Subject: Chamber Construction Manual
Posted by [Clemens Adler](#) on Thu, 25 Mar 2004 08:24:30 GMT
[View Forum Message](#) <> [Reply to Message](#)

I updated the chamber construction manual (to version 1.1).

1) [image001.gif](#), downloaded 2308 times

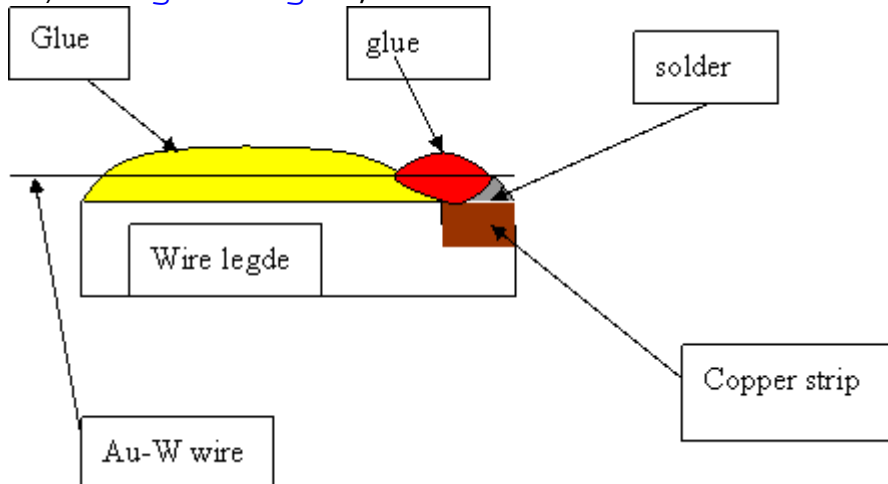
2. An suggestion: Oleg suggests to put some glue to between the glue which holds the anode wire on the wire ledge and the copper strip where the wire is soldered (see attached picture by Oleg).

"after soldering of anode wires we put glue (red color) to fix the wire, solder and copper

strip together. It is need to remember that we have to safe a clean place on the copper strip to solder HV cable."

We also had this idea and did it on some chambers, but after discussion with Joerg at GSI, who never had any similar problem we thought that probably sanding the wire ledge edges is good enough and will solve the problem.

So I would like to hear from GSI (Joerg) and Bukarest (Mihai) what they think. Since we have not put anodes on a chamber since a while due to technical difficulties with machiniery in our lab, I cannot tell at this moment what our experiences with sanding the wire ledges are. I will, therefore, not add this into the construction manual, until there are some more opinions about this additional step.
